**YAMAHA MOTOR CORPORATION, U.S.A.**

**Regarding: 03V-309  
Yamaha Recall of XV 16/17 Motorcycles Regarding Transmission**

## 2001 XV16AN, ANC, ASN, ASNC FACTORY MODIFICATION CAMPAIGN

## 2001~2003 XV16 MODELS FACTORY MODIFICATION CAMPAIGN

### Main Shaft Modification:

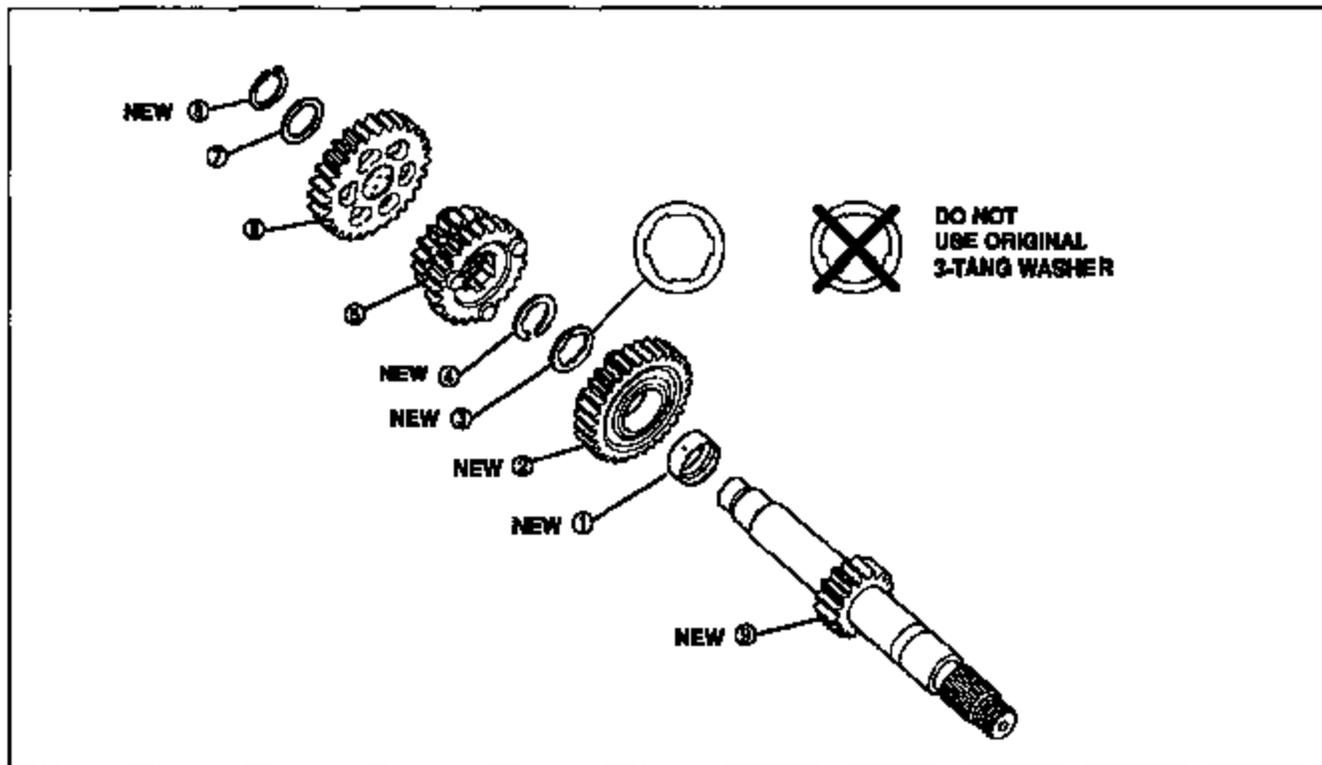
- Completely disassemble the main shaft. The Washer ⑦, 5th Pinion Gear ⑥, and 2nd/3rd Pinion Gear ⑤ will be reused.
- Install the components on the new-type Main Shaft ⑨ in the following order. Lubricate all components with engine oil. Be sure circlips are installed with the sharp edge of the inner diameter facing away from the mating washer.

- ① Collar – NEW
- ② 4th Pinion Gear – NEW
- ③ Washer – NEW
- ④ Circlip – NEW
- ⑤ 2nd/3rd Pinion Gear – Reuse original part
- ⑥ 5th Pinion Gear – Reuse original part
- ⑦ Washer – Reuse original part
- ⑧ Circlip – NEW

### Drive Shaft Modification:

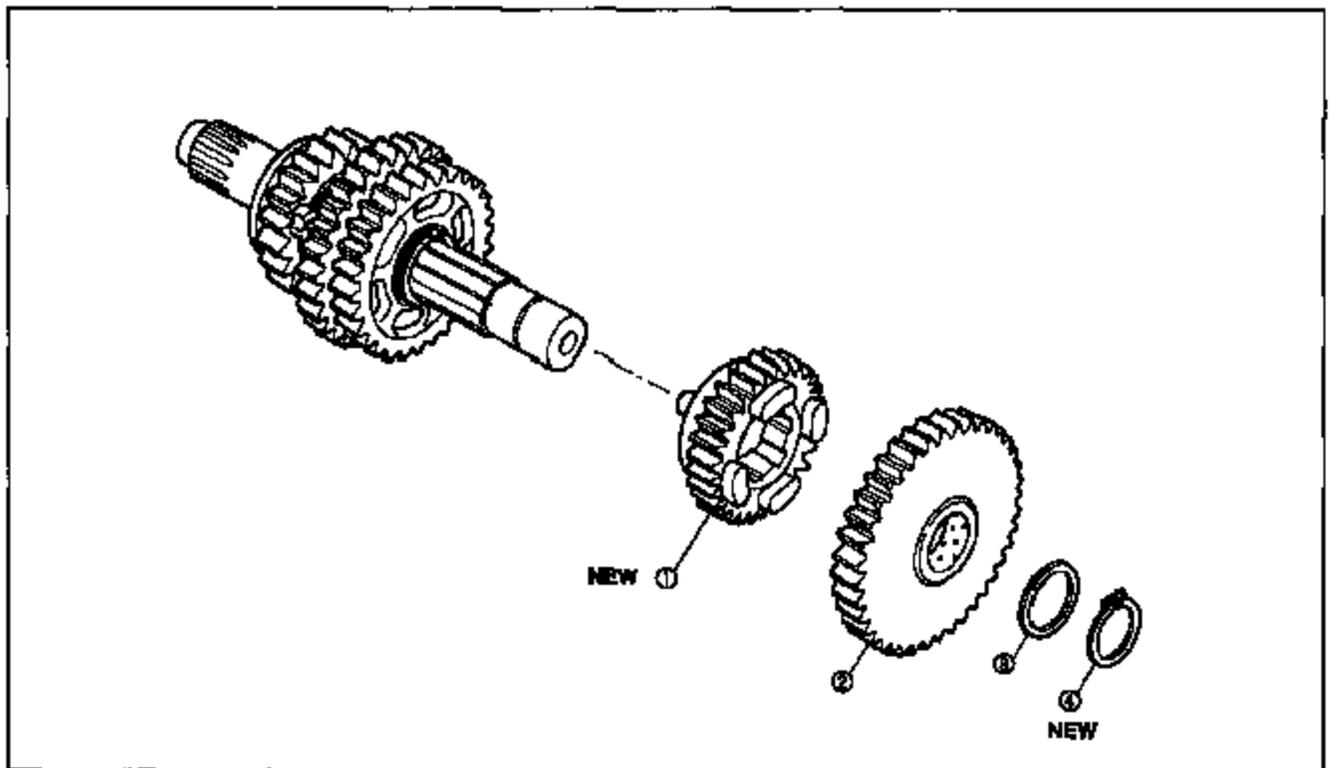
- Remove the circlip and washer from the Drive Shaft, then remove the 1st Wheel Gear and the 4th Wheel Gear. Do not disassemble the rest of the components on the shaft.
- Install the components on the original Drive Shaft in the following order. Lubricate all components with engine oil. Be sure the circlip is installed with the sharp edge of the inner diameter facing away from the mating washer.

- ① 4th Wheel Gear – NEW
- ② 1st Wheel Gear – Reuse original part
- ③ Washer – Reuse original part
- ④ Circlip – NEW

**Be sure to use all of the new parts in the kit. Otherwise, the transmission can still fail.**

### Main Shaft Modification:

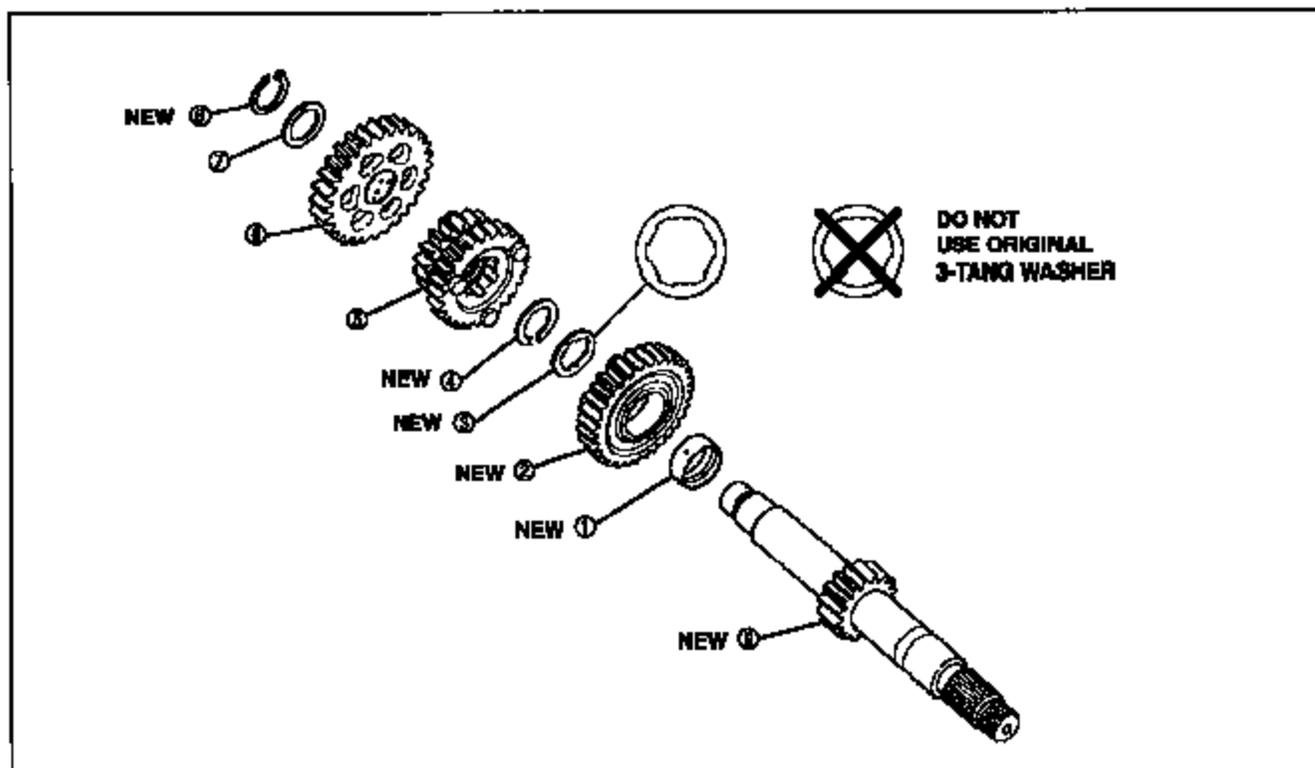
- Completely disassemble the main shaft. The Washer ⑦, 5th Pinion Gear ⑥, and 2nd/3rd Pinion Gear ⑤ will be reused.
- Install the components on the new-type Main Shaft ⑧ in the following order. Lubricate all components with engine oil. Be sure circlips are installed with the sharp edge of the Inner diameter facing away from the mating washer.

- ① Collar – NEW
- ② 4th Pinion Gear – NEW
- ③ Washer – NEW
- ④ Circlip – NEW
- ⑤ 2nd/3rd Pinion Gear – Reuse original part
- ⑥ 5th Pinion Gear – Reuse original part
- ⑦ Washer – Reuse original part
- ⑧ Circlip – NEW

### Drive Shaft Modification:

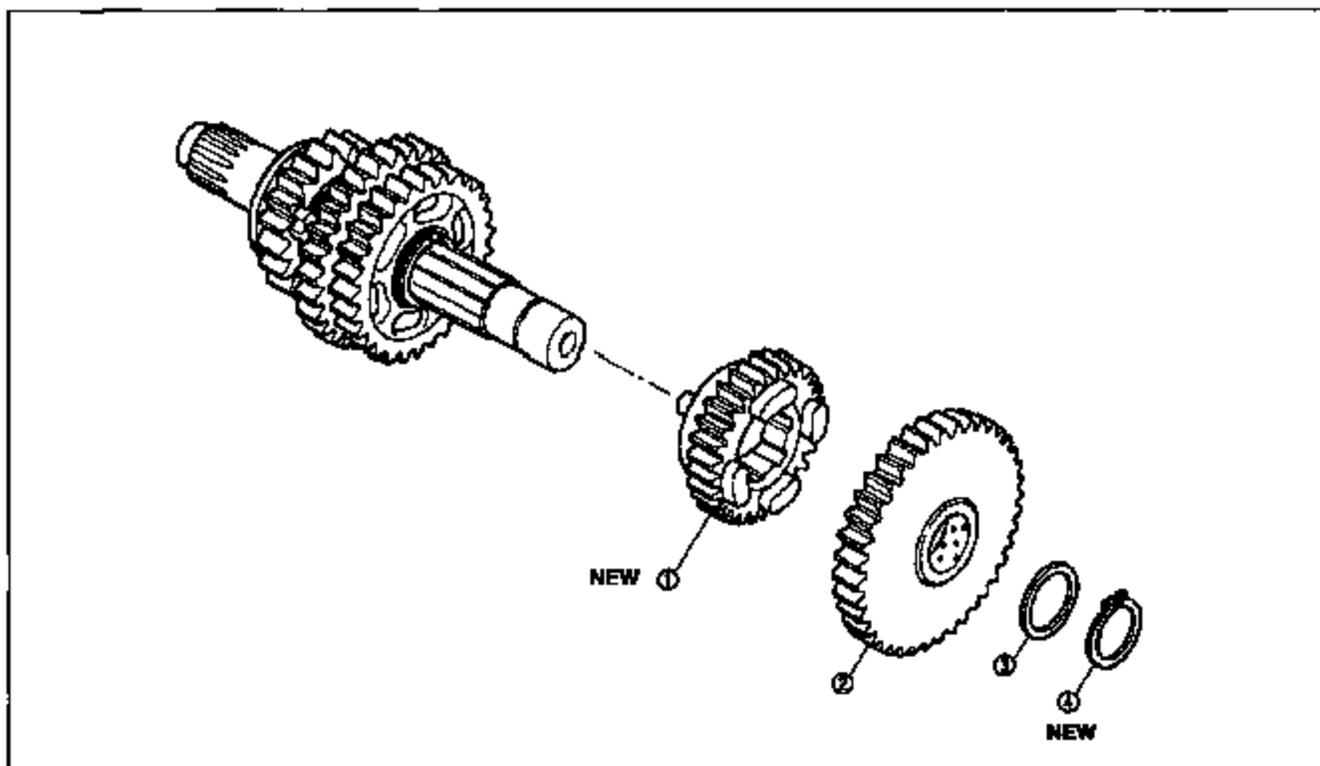
- Remove the circlip and washer from the Drive Shaft, then remove the 1st Wheel Gear and the 4th Wheel Gear. Do not disassemble the rest of the components on the shaft.
  - Install the components on the original Drive Shaft in the following order. Lubricate all components with engine oil. Be sure the circlip is installed with the sharp edge of the inner diameter facing away from the mating washer.
- ① 4th Wheel Gear – NEW
  - ② 1st Wheel Gear – Reuse original part
  - ③ Washer – Reuse original part
  - ④ Circlip – NEW

**Be sure to use all of the new parts in the kit. Otherwise, the transmission can still fail.**
